**Proposed Photovoltaic Solar Array on
Land at Priory Farm to the east of
Great Wymondley
Hertfordshire**

LANDSCAPE AND VISUAL REVIEW

North Hertfordshire District Council

Doc Ref: B22036/01

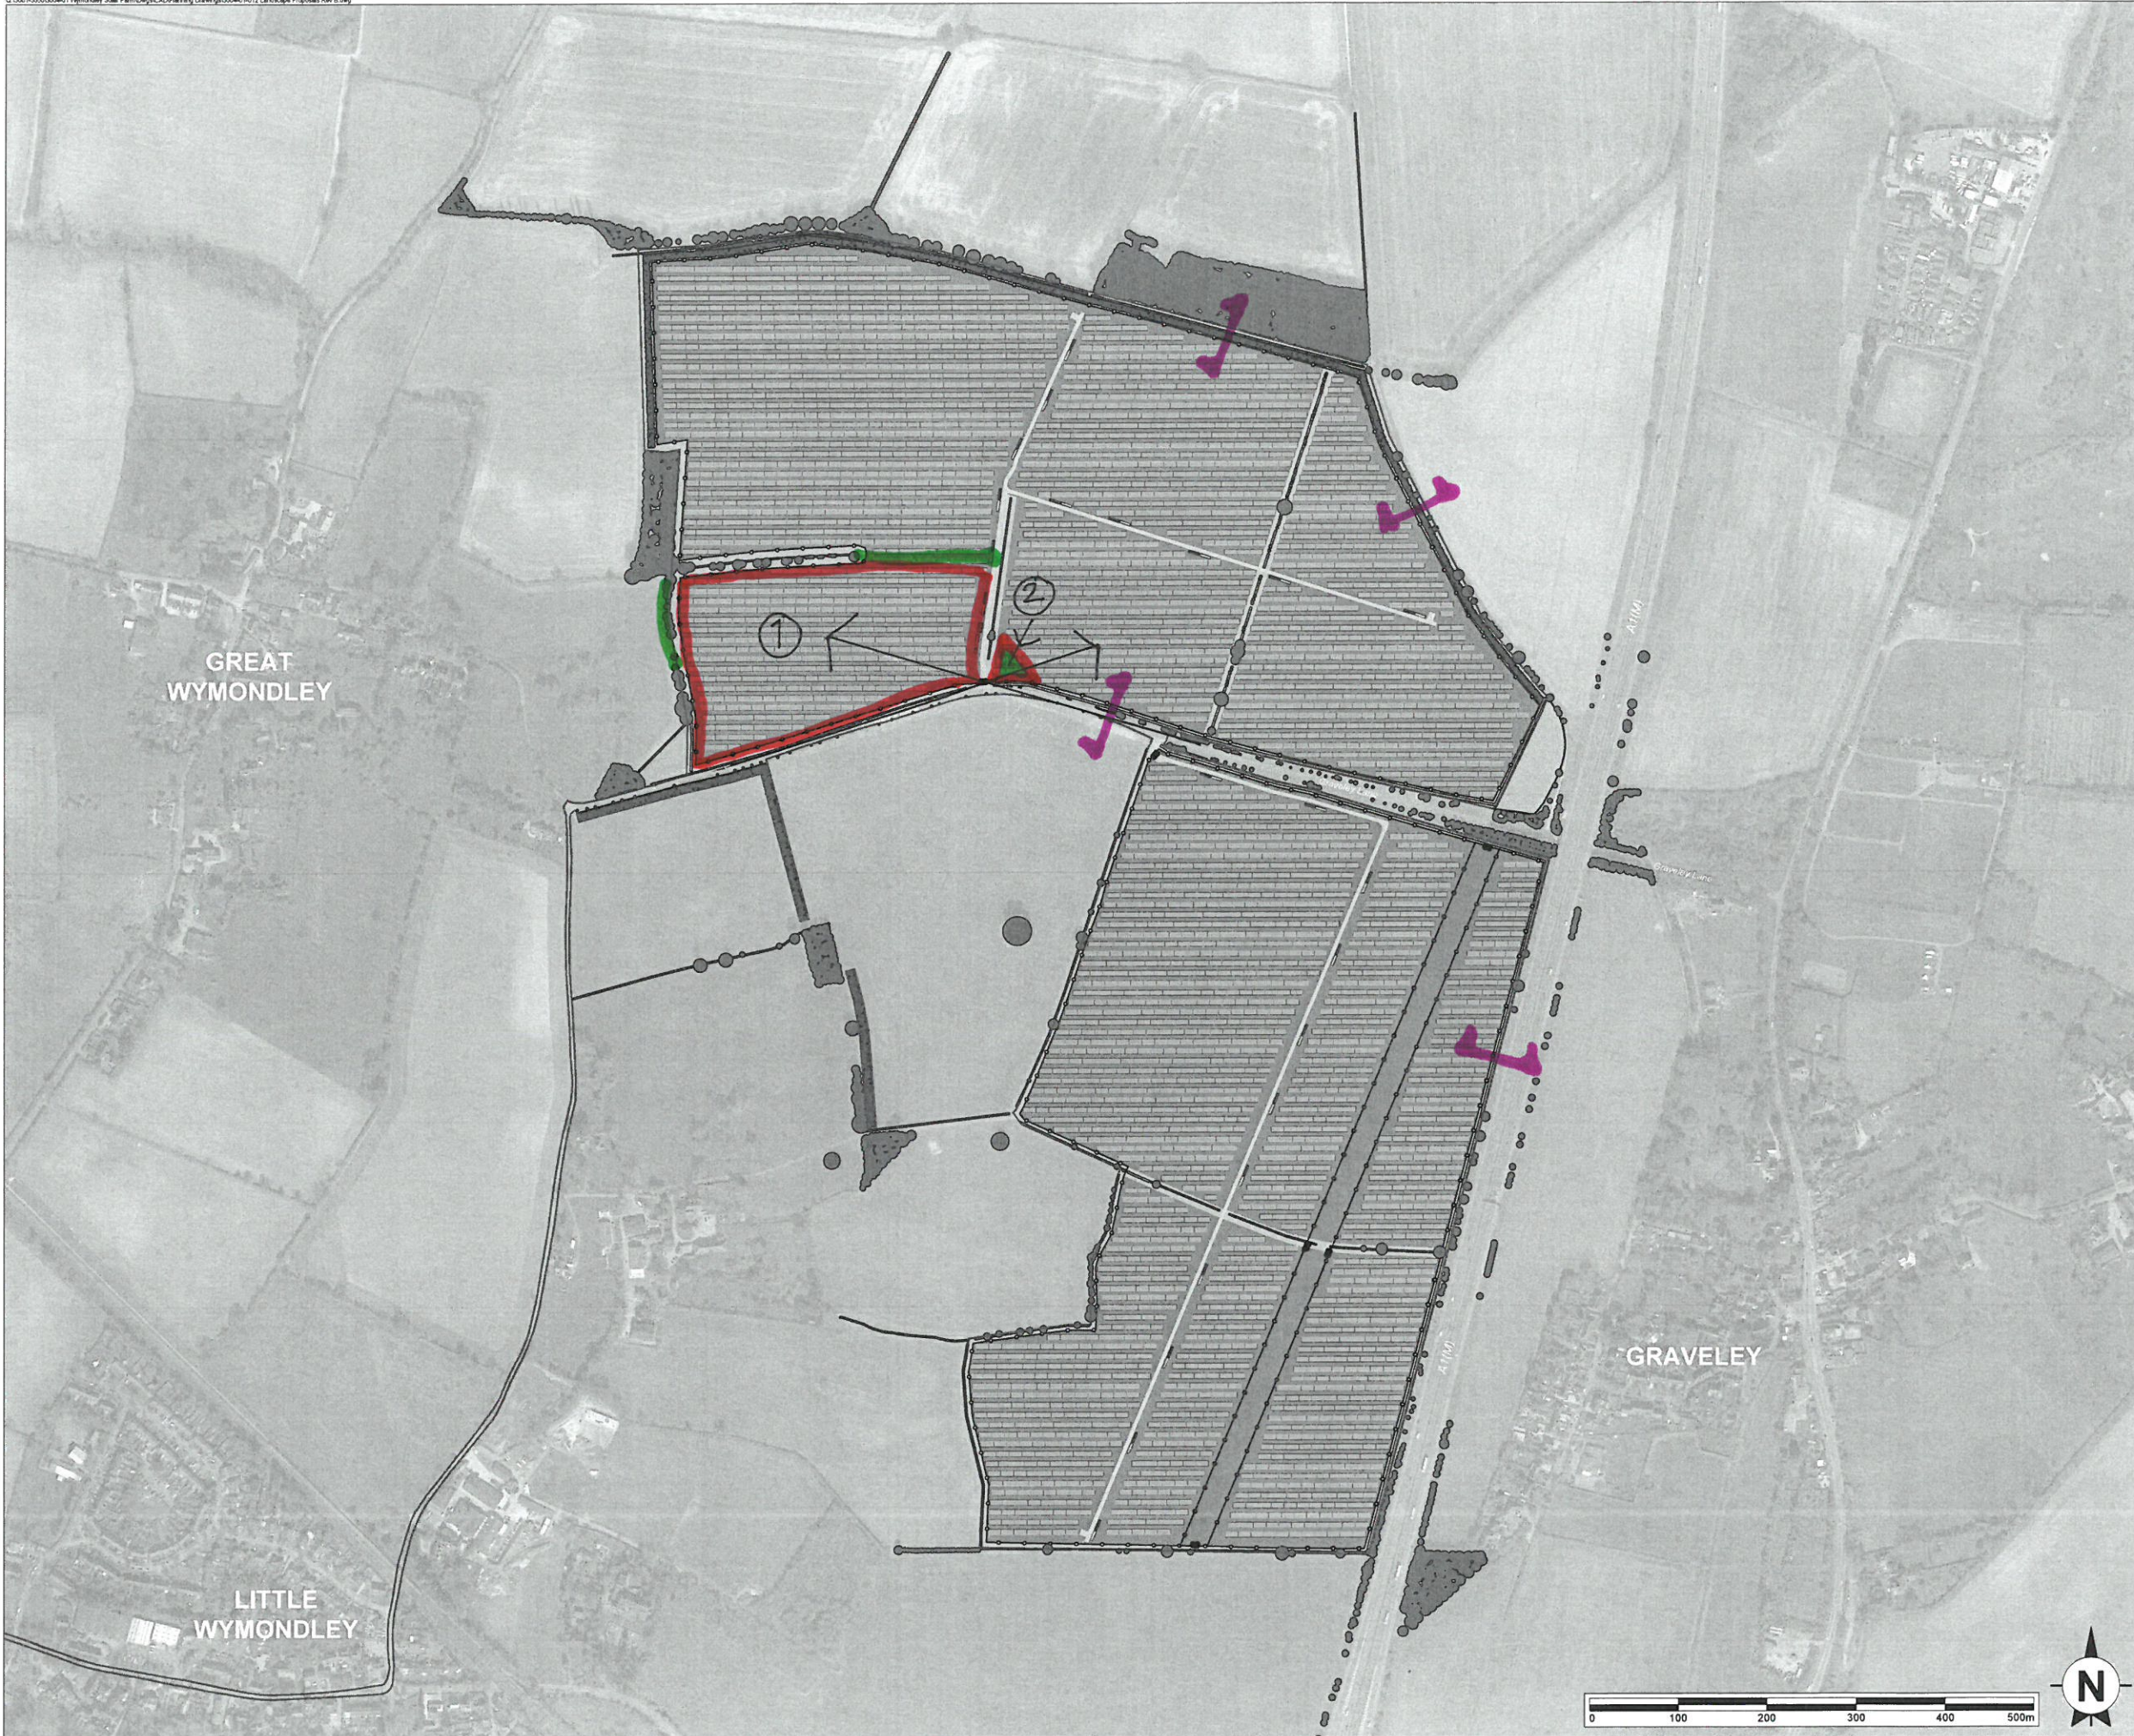
- a. Reduction of the extent of solar panels on the land closer to Great Wymondley.
- b. Localised removal of panels to provide for more planting at one location on Graveley Road where there would be direct views to the north-east into the northern part of the Site.

5.5.3 The locations where modifications are recommended are shown on the attached mark up of Figure 1 at Appendix 1 to this review. Locations 1 and 2 are indicated with the reasons being:

Location 1 – omit panels on sloping land closer to Great Wymondley with views from the village edge and rights of way and in west facing views along Gravely Lane. Add hedgerow to north boundary of field to extend finger to plating to join existing hedge to the east.

Location 2 – Create space for small copse of medium scale trees and shrubs to screen views from Graveley Lane to looking east.

- 6.1.3 The landscape proposals are set out on Figure 1 – an A3 drawing at 1:40,000 scale. This is suitable to show an overview of the whole site at A3. However, TLP recommend the inclusion prior to determination of a sheet of typical cross sections at a larger scale c 1:50 to show the arrangement with retained and proposed hedges, woodland, fencing, panels and wildflower grassland areas. Potential locations marked on attached Appendix 1.
